**Report: TAB Report**  
**Function: Test, Adjust, & Balance**  
**Date: 7/13/2022**

**PROJECT**  
**FIVE GUYS #2036 - MADISON, AL**

Project: FIVE GUYS #2036 - MADISON, AL

**Issue Name :** Restroom dampers inaccessible

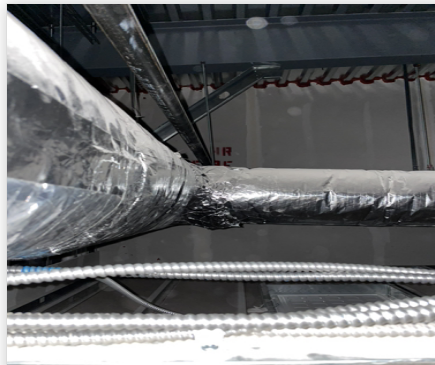
**Description :** Dampers for restrooms are above hard ceiling and are not accessible to adjust. Suggest remote dampers or face dampers be installed when hard ceilings are installed.
